ADDENDUM NUMBER ONE

Indiana University
Launch Accelerator for Biosciences
1302 Indiana Ave.
Indianapolis, IN 46202

Addendum Dated: OCT 16, 2025

IU Project #: 20250072
BSALS Project #: 00360481

S300

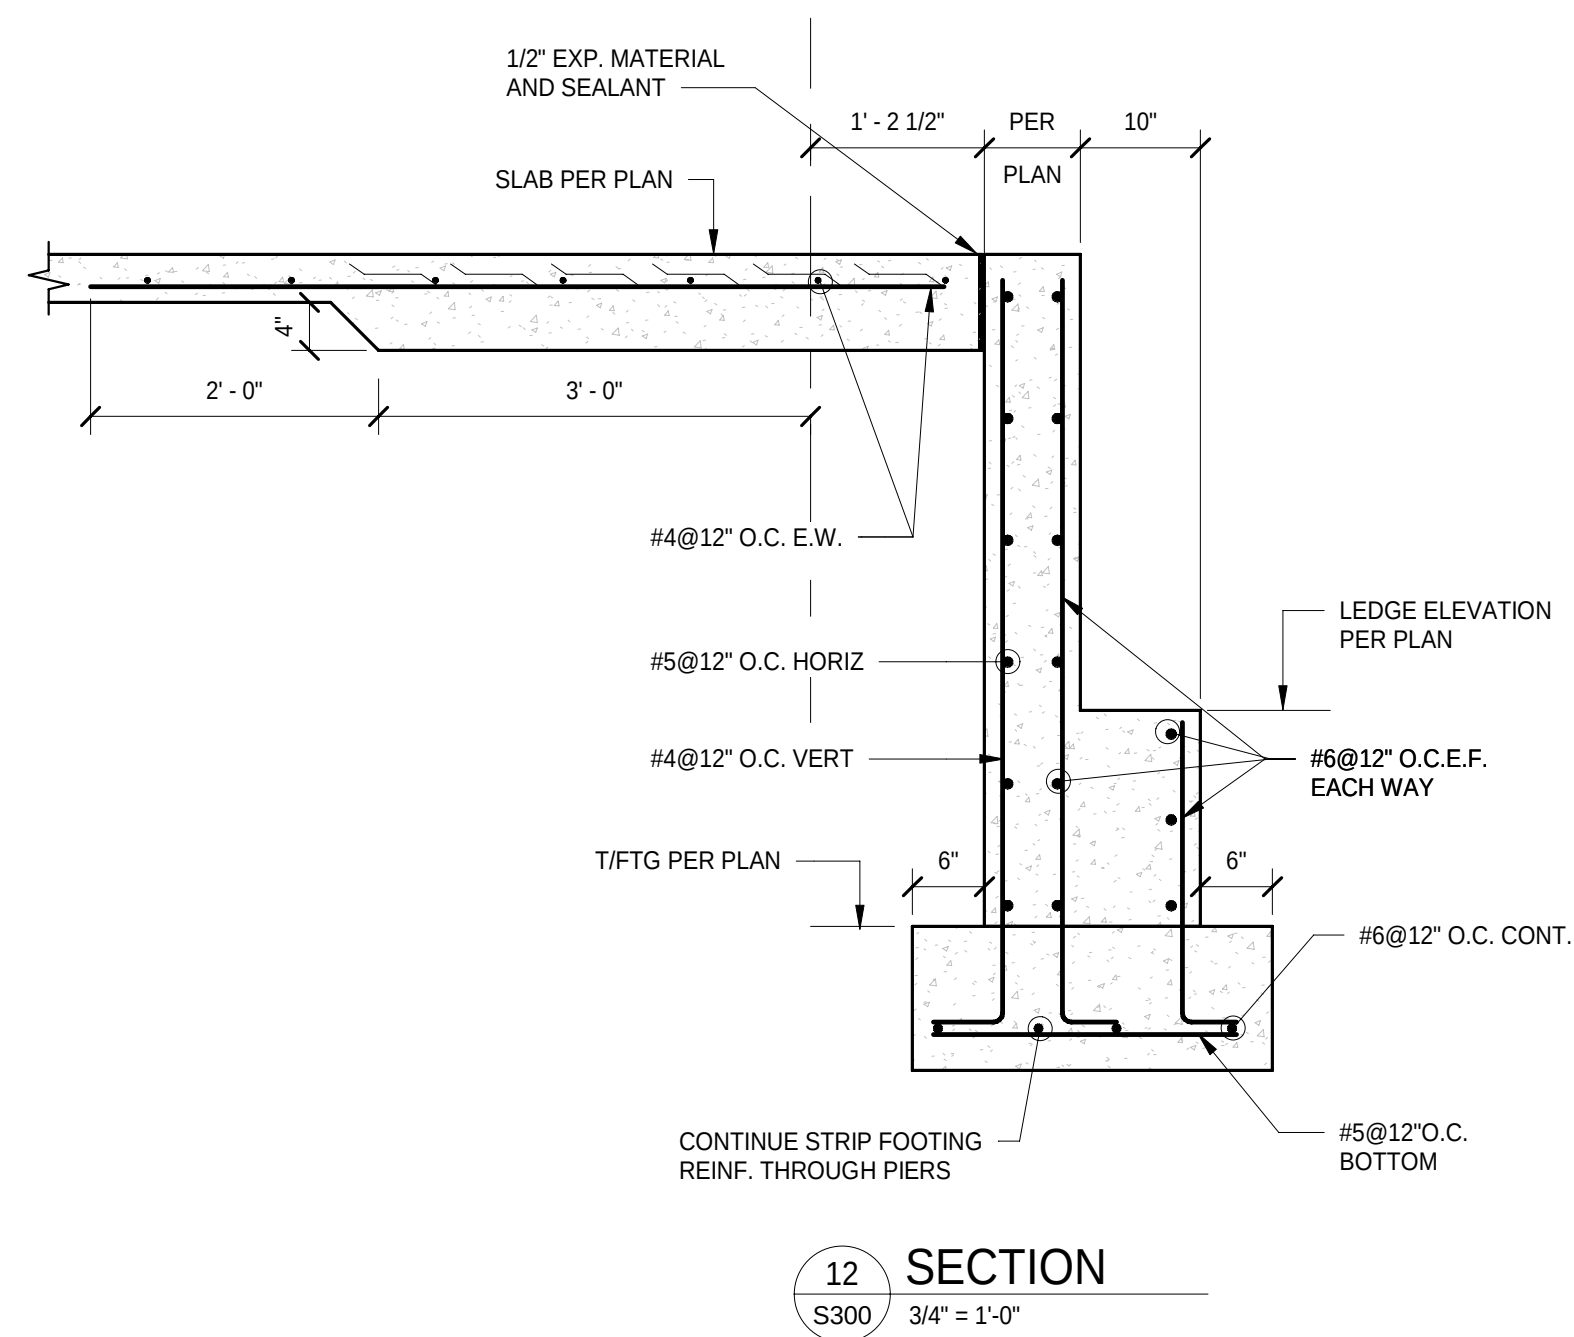
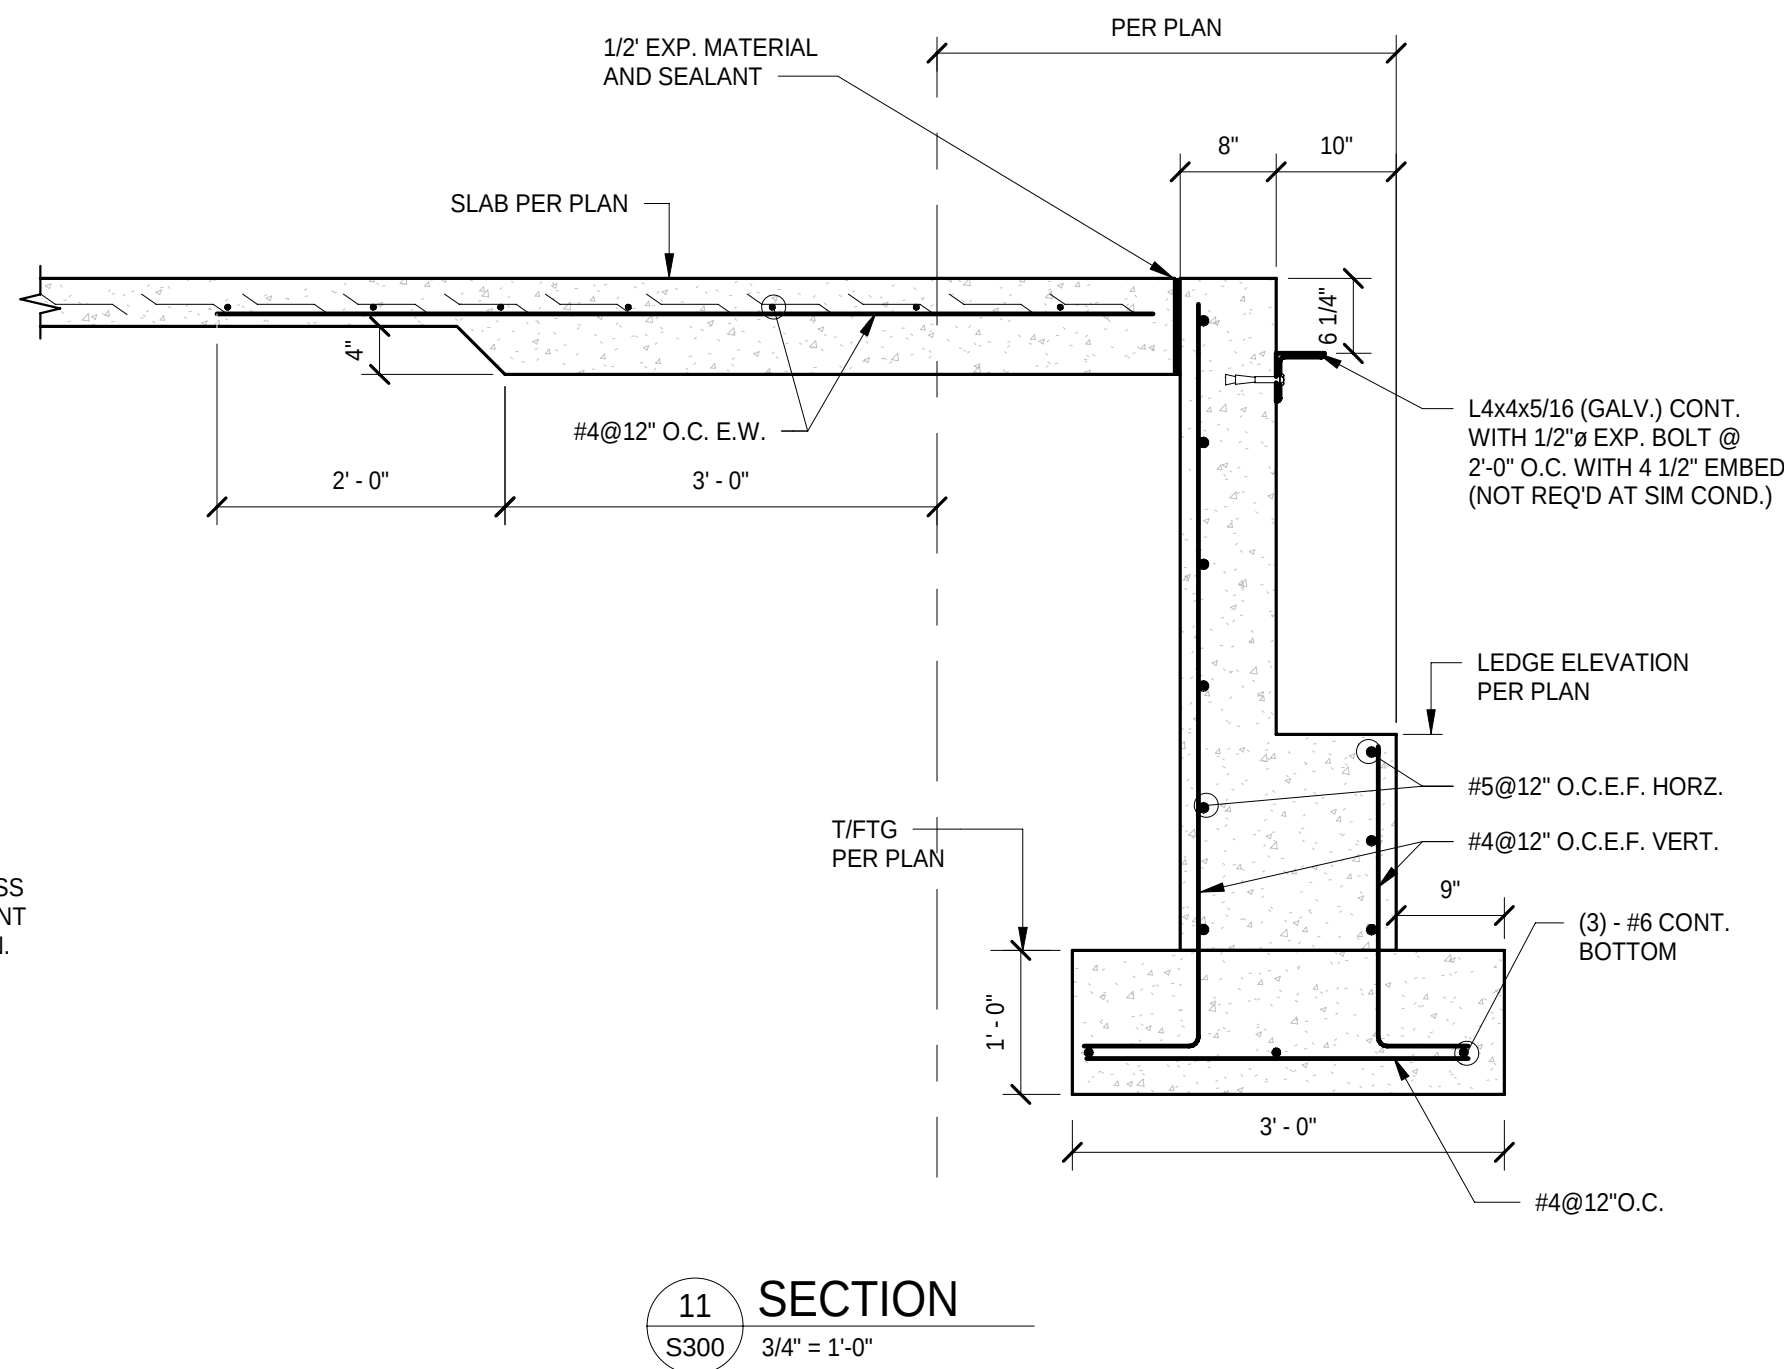
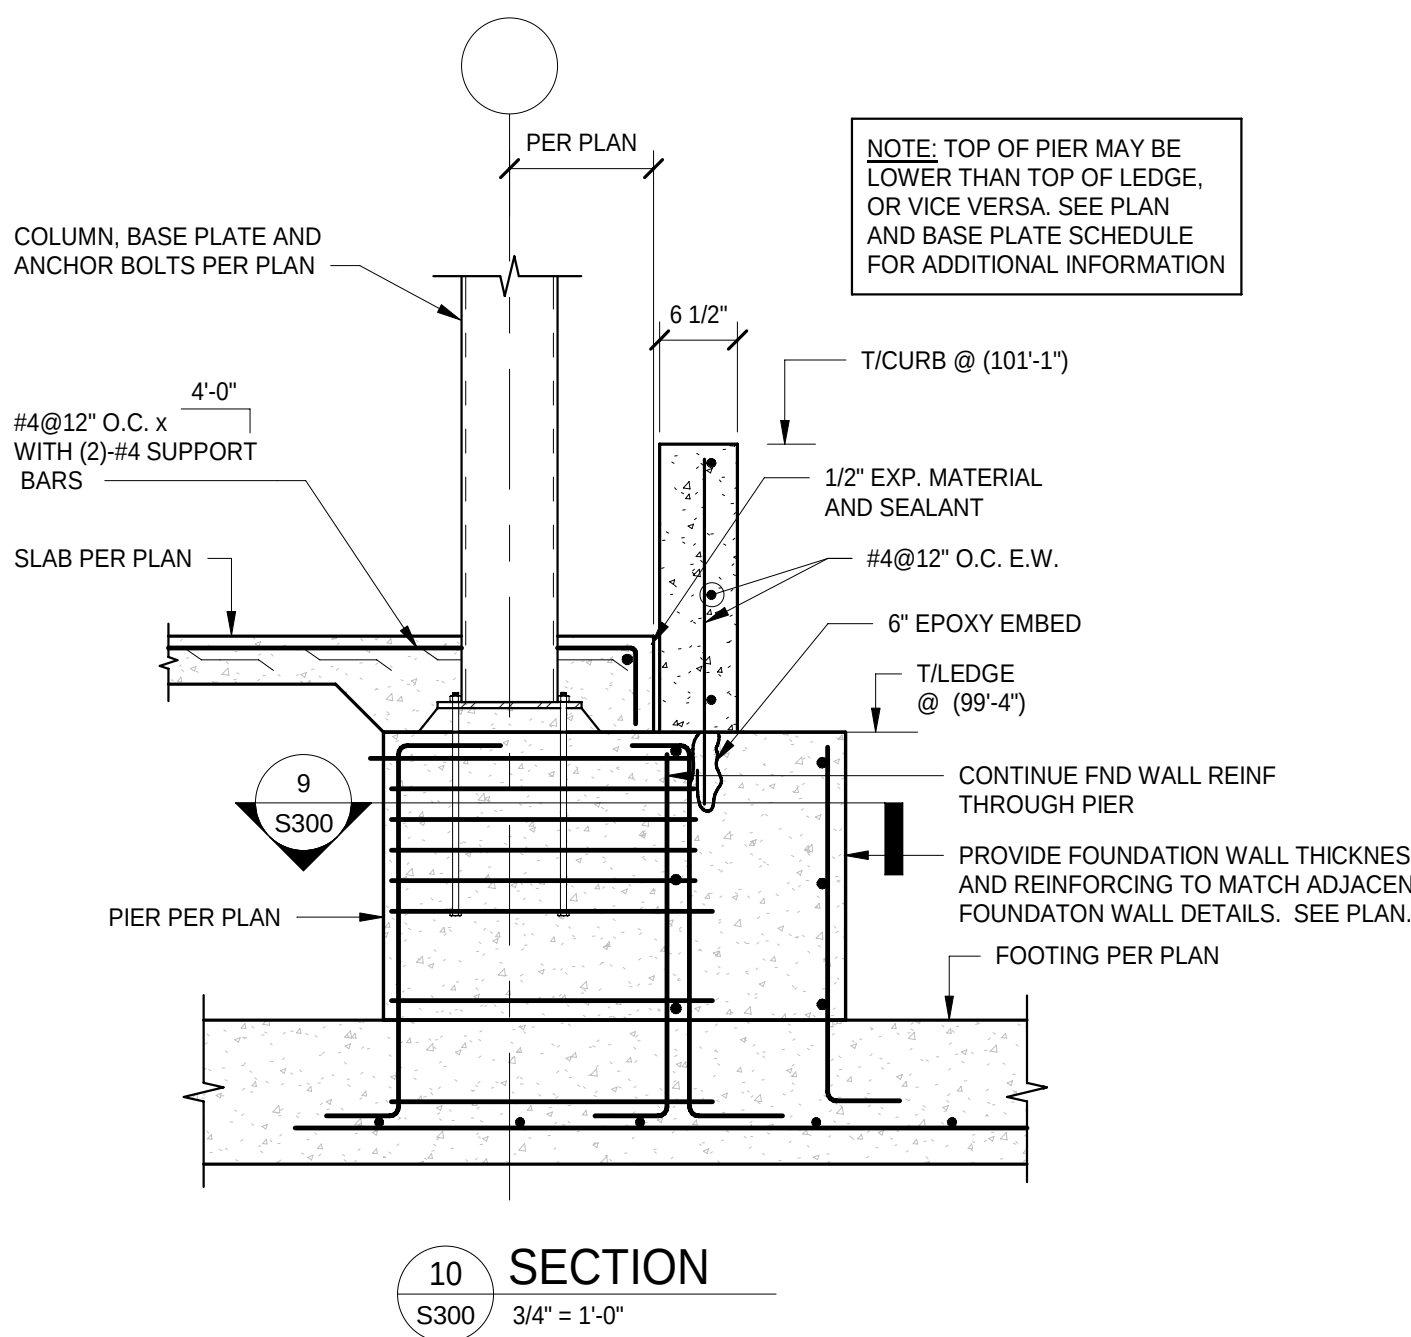
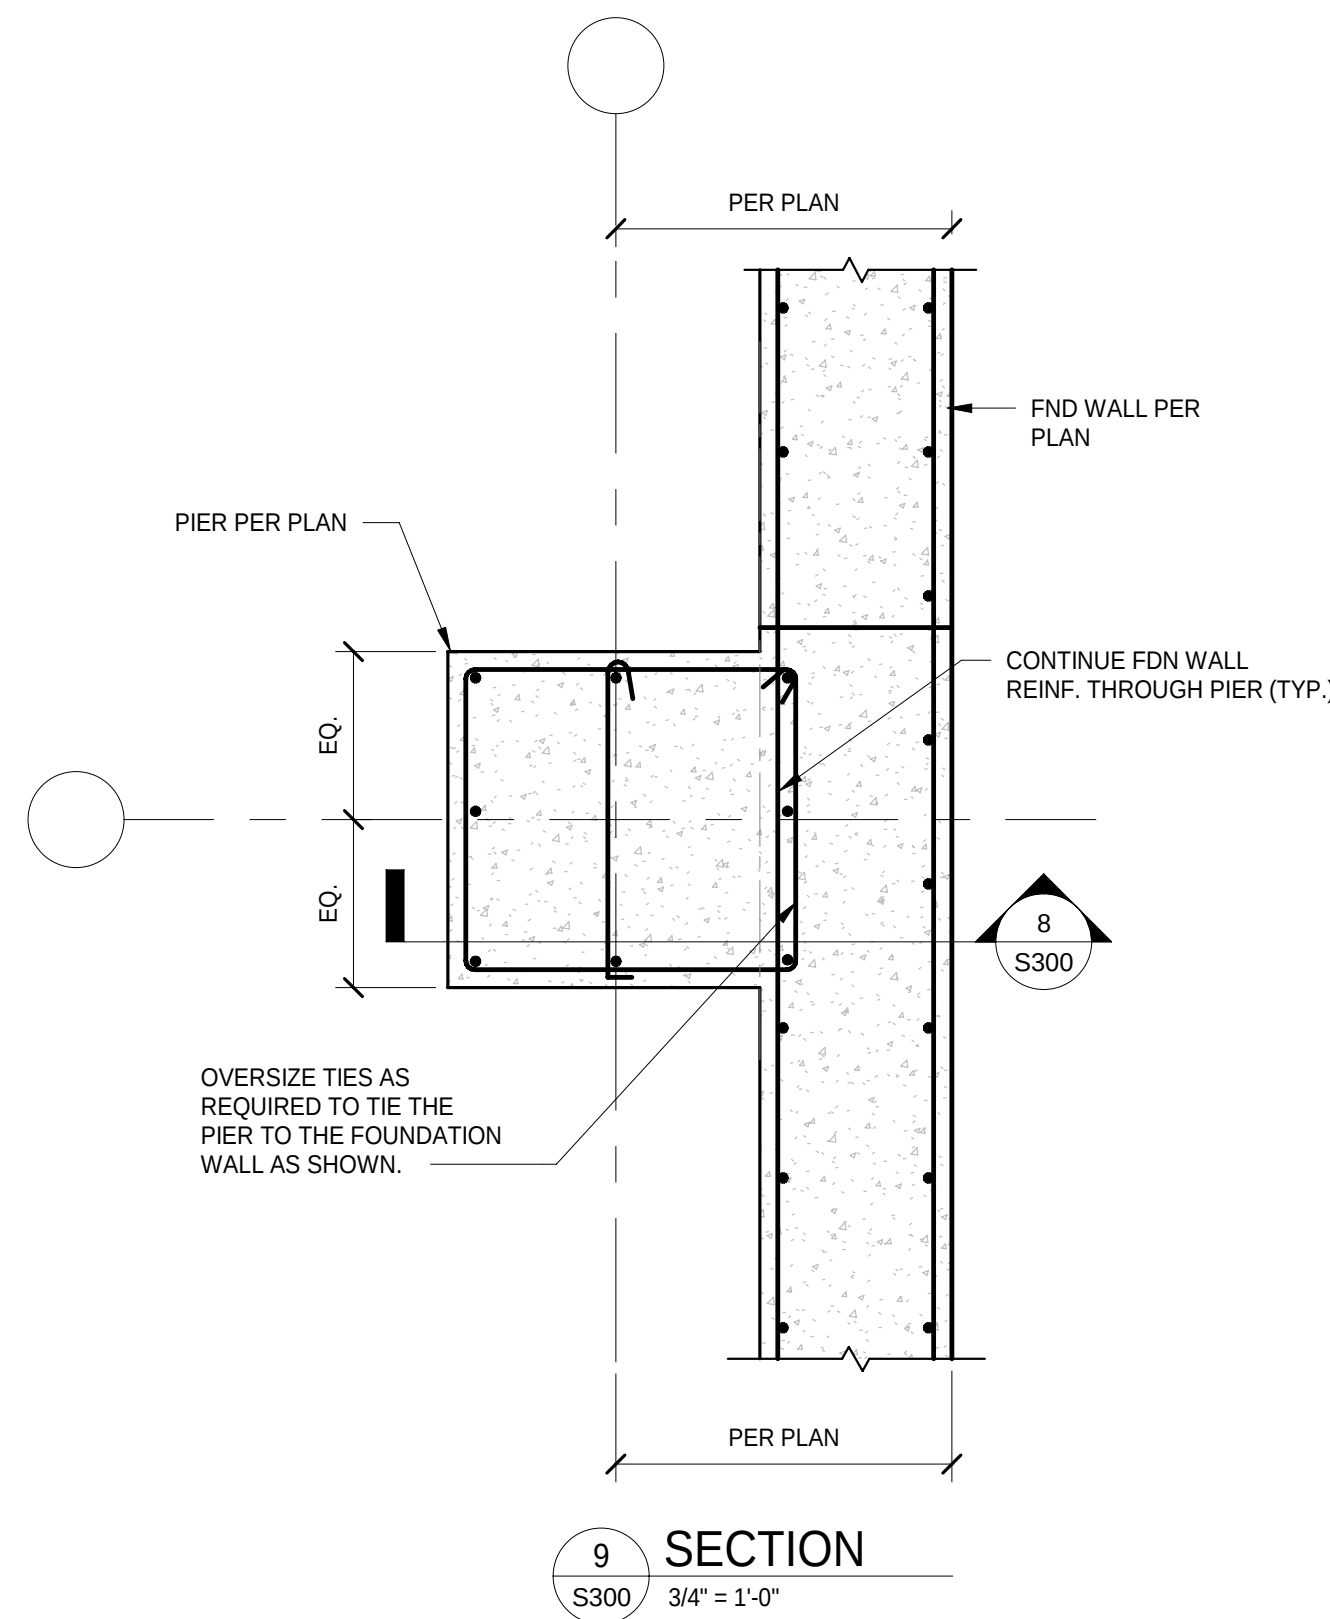
- j. Add brick ledge step along D line at 14 line as shown on the clouded portion of the attached revision drawing.
12. **Sheet S300:**
- a. Modify the "PER PLAN" dimension line on S300-06 as shown on the clouded portion of the attached revision drawing.
